Submitted to the Planning Board by
Alan Robillard

Nitrogen (N) Calculation

MVC Nitrogen Calculation

Plan of Land in
Oak Bluffs, Massachusetts
Surveyed for
Lagoon Ridge, LLC

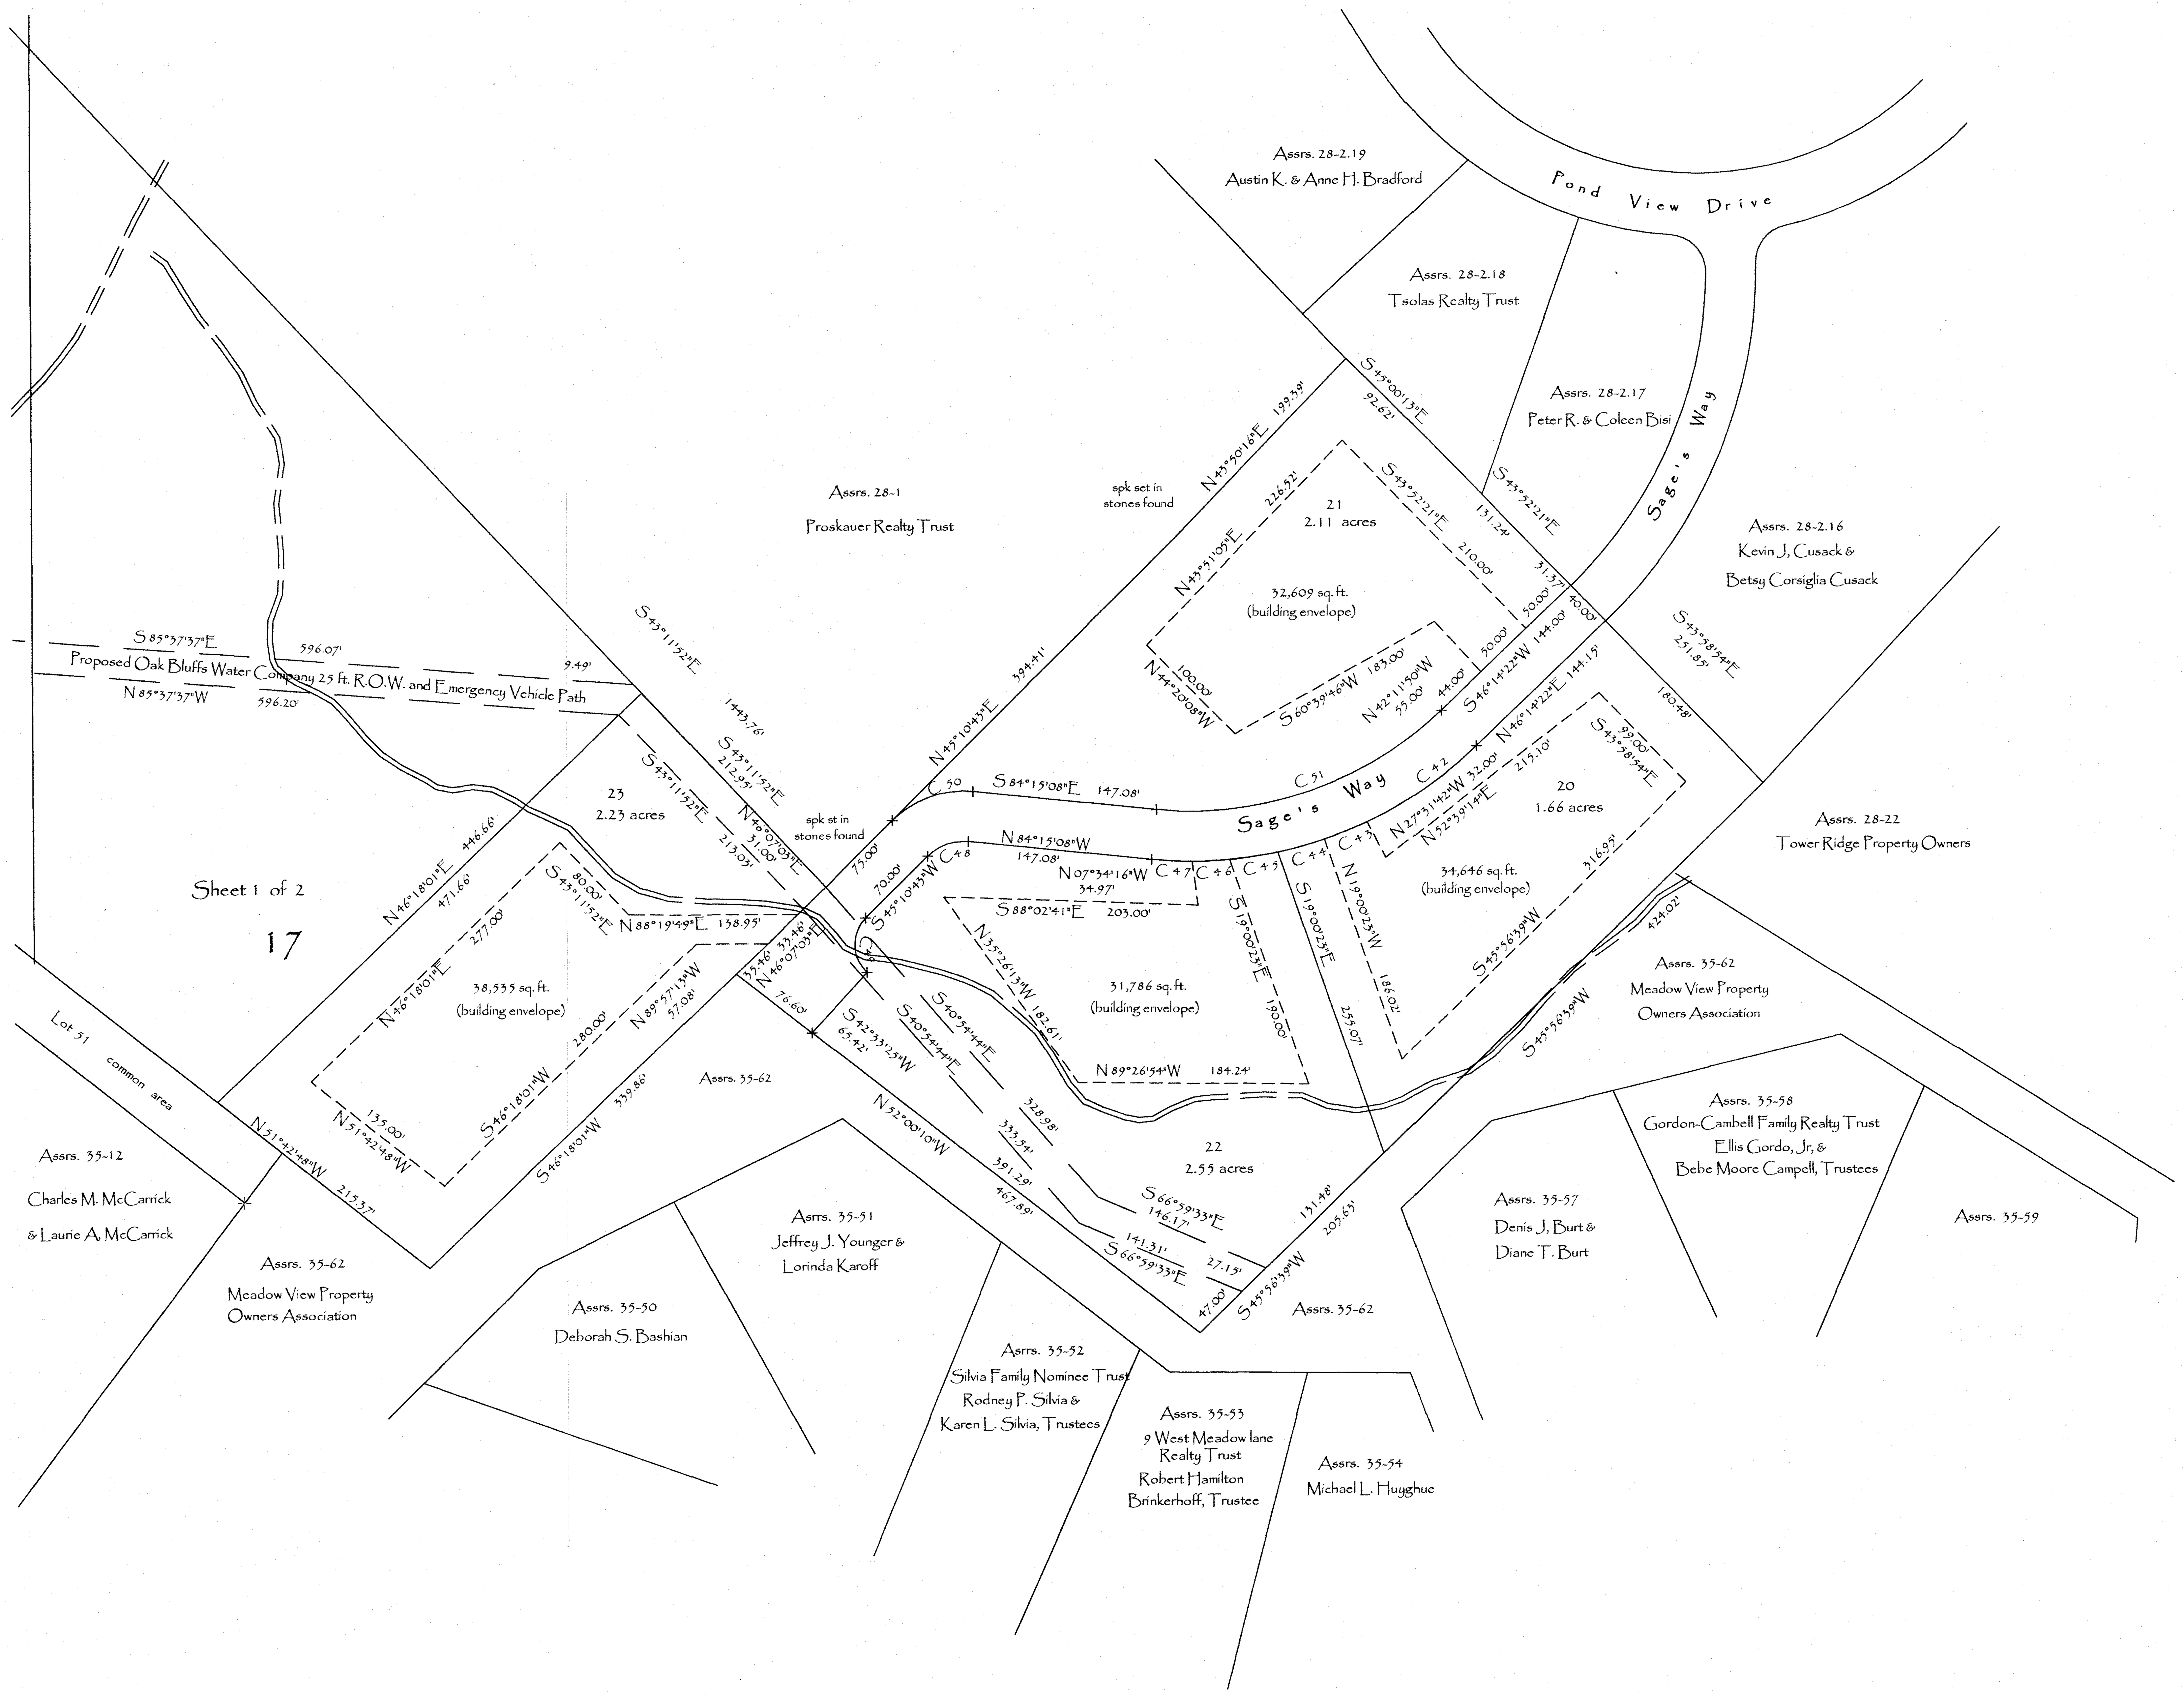
-1. **The entrance road -** The road to be paved is approximately 400 feet long X 40 foot ROW leading from Barnes Road to the entrance of Section B. This is shown on the plan, but is not likely to have been considered in the plan's acreage nor in the nitrogen calculation. To understand why this area was not considered you must compare the MVC form B plan (Attachment 1) and the MVC form C plan (Attachment 2) to the applicant's plan for the special permit, dated April 13, 2017 which is in your hands. Neither the MVC form B plan nor Form C plan define the new 400 feet of paved road implying it was not considered for N loads.

-2. **The Bike Path -** The area of trees to be cut down for the paved bike path on Barnes Road...approximately 300 ft X 20 foot ROW -Not shown on Attachments 1 and 2; therefore, not likely to have been considered for N load by the MVC.
